STATE OF CONNECTICUT
CONNECTICUT SITING COUNCIL

IN RE: :
 :
APPLICATION OF CELLCO PARTNERSHIP : DOCKET NO. 448
D/B/A VERIZON WIRELESS FOR A :
CERTIFICATE OF ENVIRONMENTAL :
COMPATIBILITY AND PUBLIC NEED FOR :
THE CONSTRUCTION, MAINTENANCE :
AND OPERATION OF A WIRELESS :
TELECOMMUNICATIONS FACILITY AT :
831 DERBY MILFORD ROAD, ORANGE, :
CONNECTICUT : SEPTEMBER 9, 2014

RESPONSES OF CELLCO PARTNERSHIP d/b/a
VERIZON WIRELESS TO THE COUNCIL'S PRE-HEARING QUESTIONS SET 3

Alternate Sites Evaluated

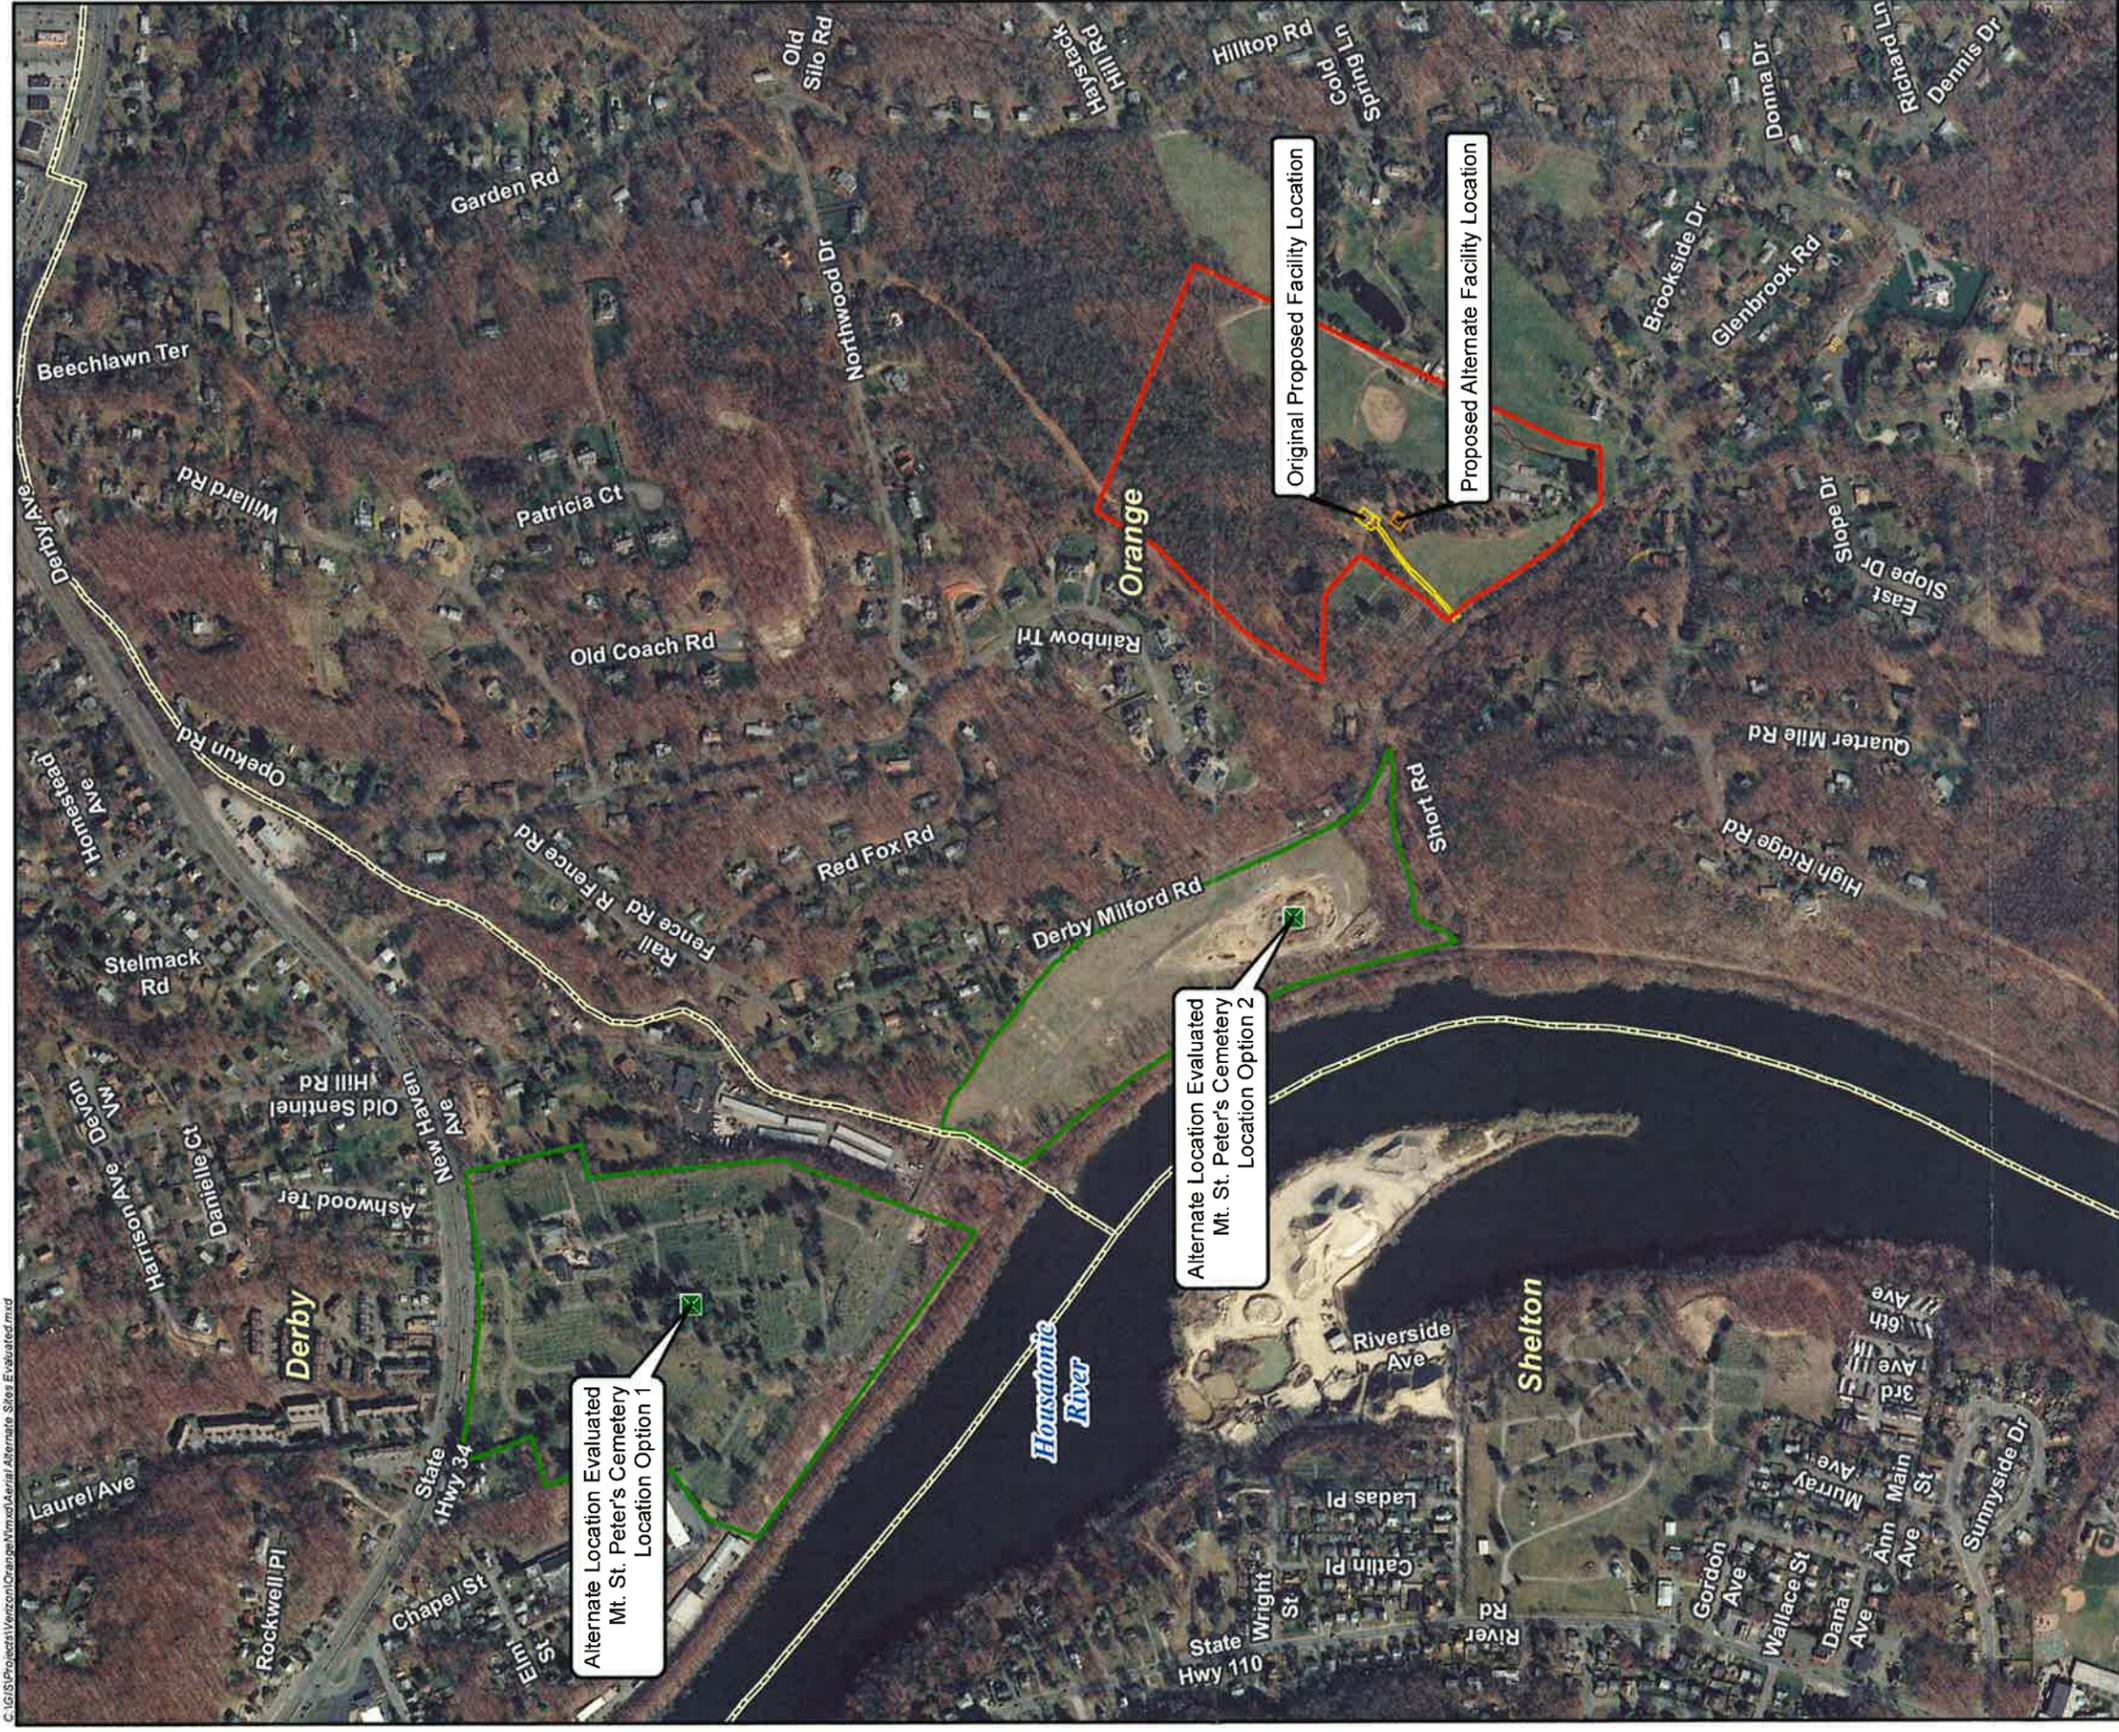
If a site is viable at the Mount Saint Peter's Cemetery in Derby, would it supplant the need for both the Docket 448 site and the 111 New Haven Avenue Derby site? Please explain.

Either location on the cemetery property would be visible to more locations throughout the year. Compared with the proposed 100-foot tall Orange North tower (which is estimated to be visible, at least to some degree, from up to 346 acres), a tower located at the cemetery (with increased heights of 100 to 120 feet or higher) could be more visible anywhere from nearly two to over three times the total area. Beyond a quantitative acreage evaluation, the number of residences with potential views of a tower at either of the cemetery locations also increases more than three-fold. Residential areas immediately north (across Route 34) and east of the cemetery are also not afforded the dense tree buffer that exists around the proposed Orange North tower site. In addition, given the cemetery's location next to the Housatonic River, mostly unobstructed views would extend significantly to the west. A notable feature associated with Cellco's original proposal is the presence of a large hill rising to the west, which obstructs direct lines of sight across the Housatonic River in that direction. An aerial photograph showing the Option 1 and Option 2 locations at the Mount Saint Peter's Cemetery and their proximity to the

proposed Orange North cell site is included in Attachment 6.
